RE: St. Mark's Street Relocation at Marlborough Street Intersection
Planning Board Reports to Select Board under MGL c41 s81i

RE: St. Mark's Street Relocation at Marlborough Street Intersection
Planning Board Review per MGL c41 s81i – Report and Recommendations

RE: **St. Mark's Street Discontinuance** (Portion Related to St. Mark's Street Relocation)
2023 Annual Town Meeting Article 12 - St Mark's Street Discontinuance
Planning Board Review per MGL c41 s81i - Report and Recommendations

RE: St Mark Intersection, Southborough, MA
Design Review
Fuss & O'Neill Reference No. 20060933.S14

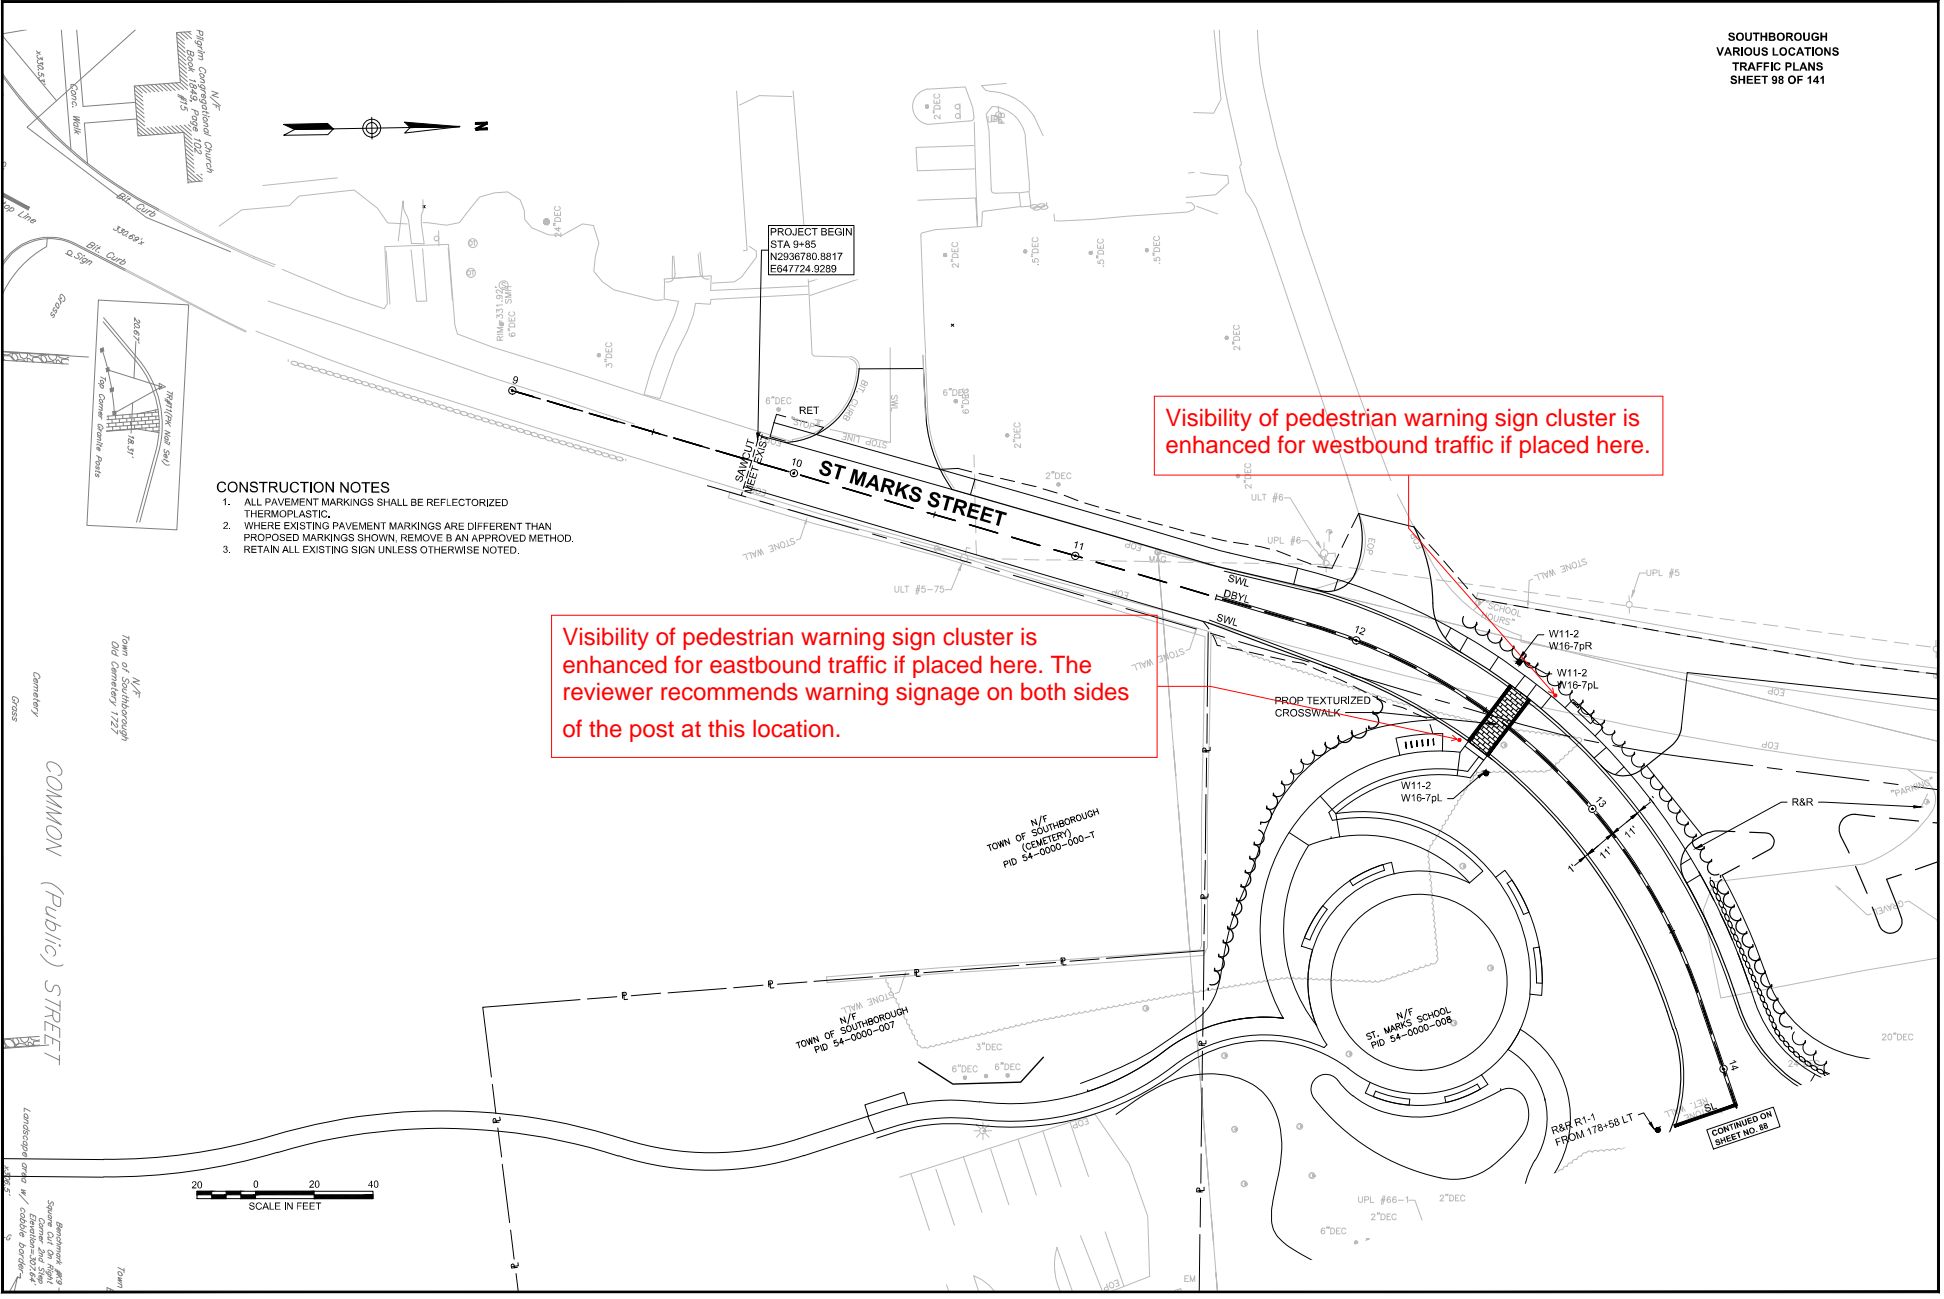
Visibility of pedestrian warning sign cluster is enhanced for westbound traffic if placed here.

Visibility of pedestrian warning sign cluster is enhanced for eastbound traffic if placed here. The reviewer recommends warning signage on both sides of the post at this location.

› *"Required traffic signage is provided in the design. The visibility of the pedestrian warning sign clusters (W11-2, W16-7pR/L) at the proposed new crosswalk on St. Marks Street could be enhanced by placing the signs on the side of the crosswalk closest to approaching traffic. Also, visibility could be increased by mounting signs on both sides of the post at each end of the crosswalk. The proposed design currently has just one of two posts displaying pedestrian warning signs on both sides of the post. See attached markup of Sheet 98 of 141 Traffic Plans."*

Response: Signage will be retained as shown because they were located to provide maximum sight lines based on the curvature of the road and to avoid pedestrians being blocked by the sign. An additional sign will be added so that the warning sign is on both sides of the post in all locations.

DISCONTINUANCE PLAN
IN
SOUTHBOROUGH
MASSACHUSETTS

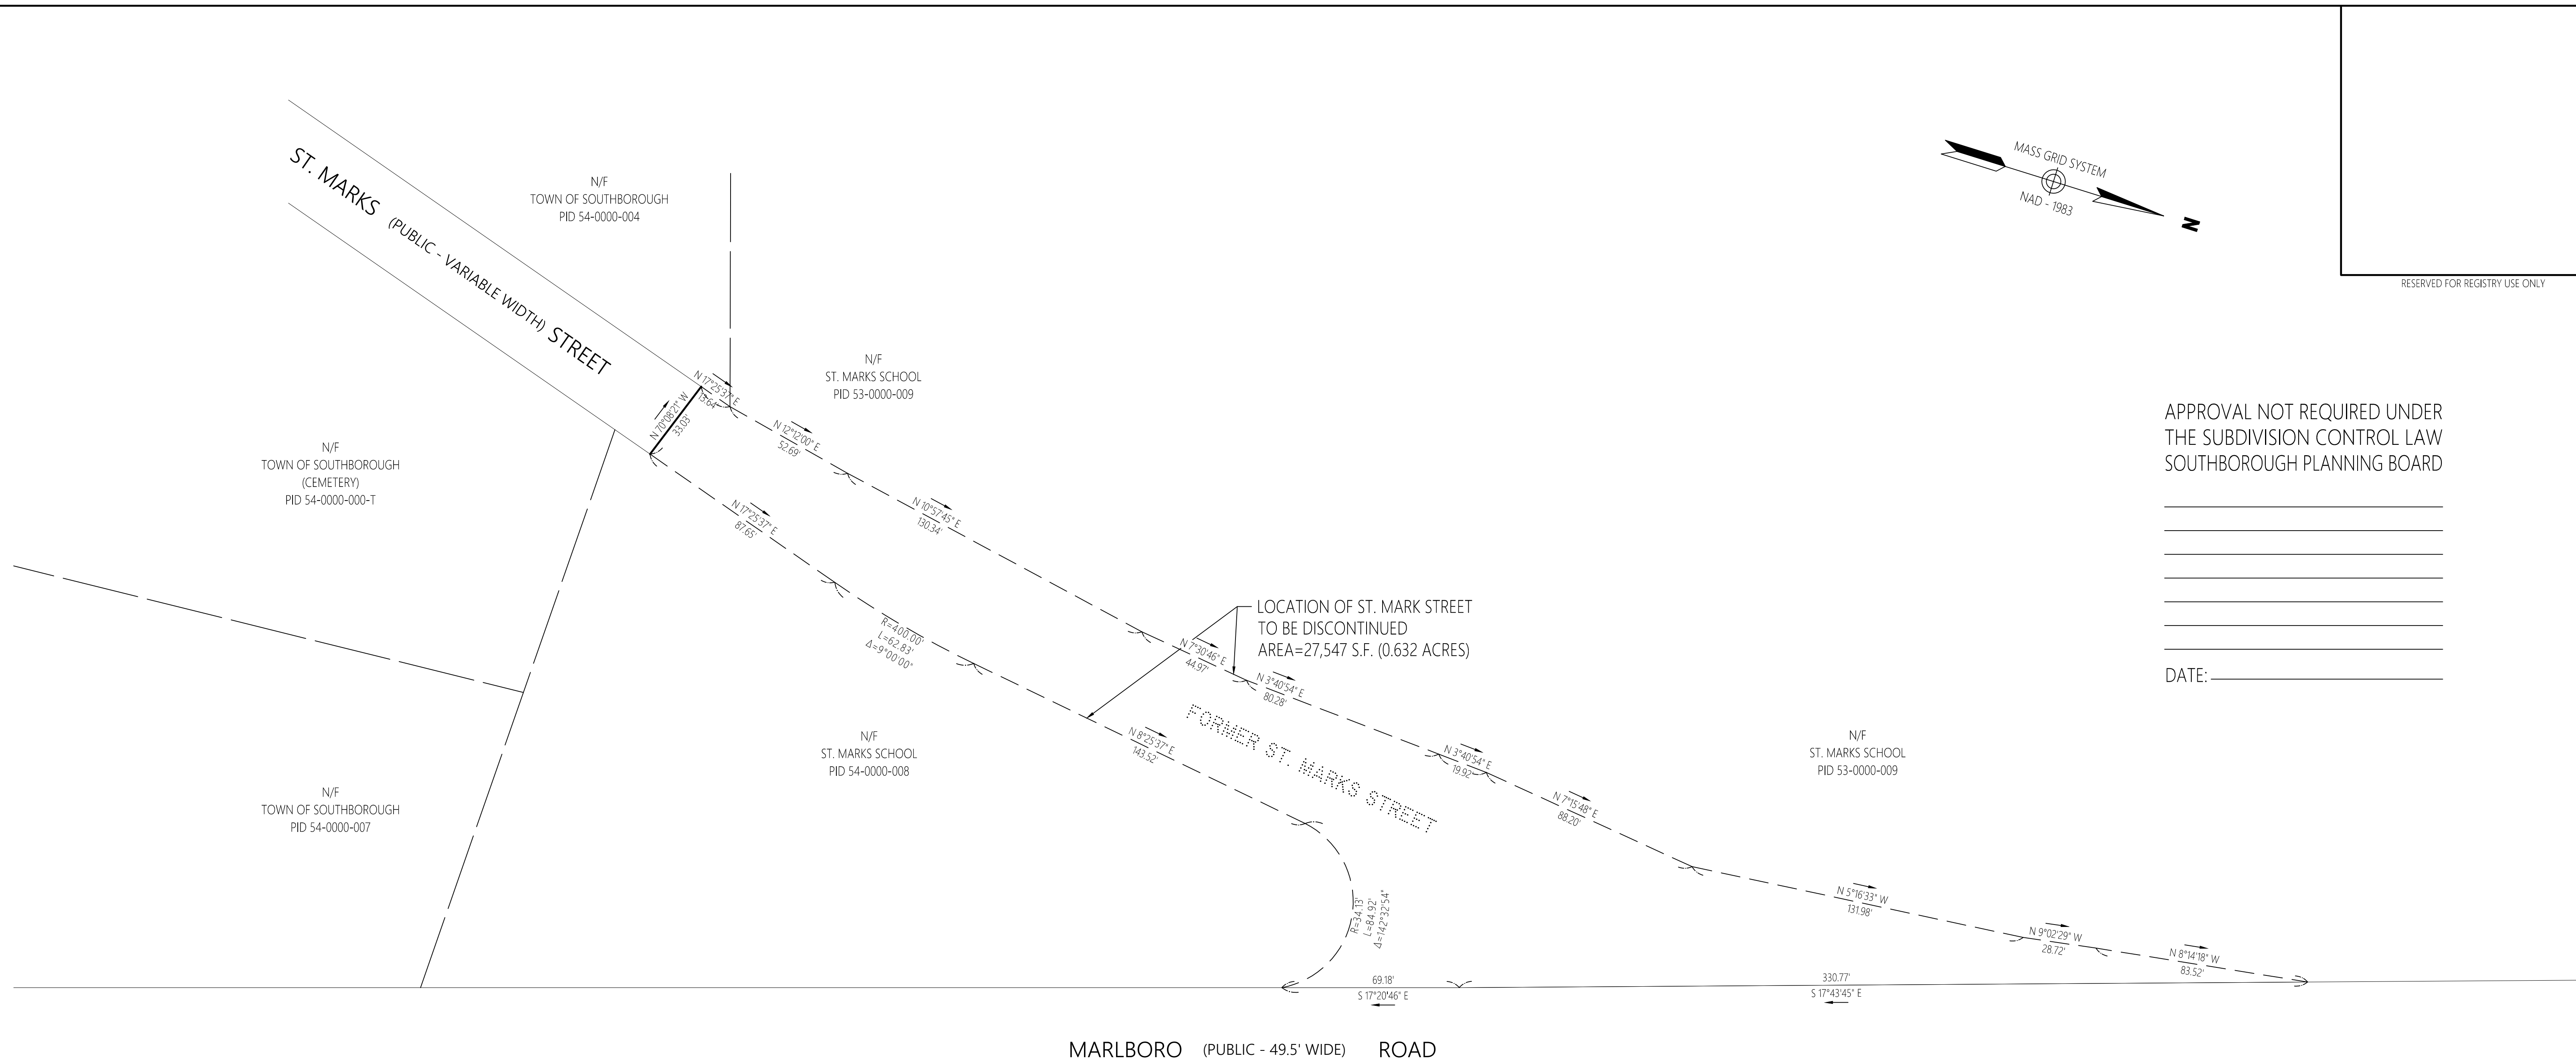
3. The Discontinuance Plan is not stamped and signed.

4. It is unclear from the Discontinuance Plan if the stone wall (along with landscaping) that St. Mark's School built along the northern corner of St. Mark's Street on Town property and subject to the 2018 reciprocal license agreement, will be part of the conveyance to St. Mark's School.

The existing stone wall should be shown on the plan to clarify location. The Discontinuance Plan should show the exact boundary proposed and features such as the stonewall to indicate their location to see who will own after the parcels are conveyed.

5. If the stonewall along the northern corner of St. Mark's Street, which is subject to the 2018 license agreement, is intended to be conveyed to St. Mark's School, how does that effect the license agreement?

Town Meeting should be presented with a Discontinuance Plan that is stamped and signed by a professional land surveyor.
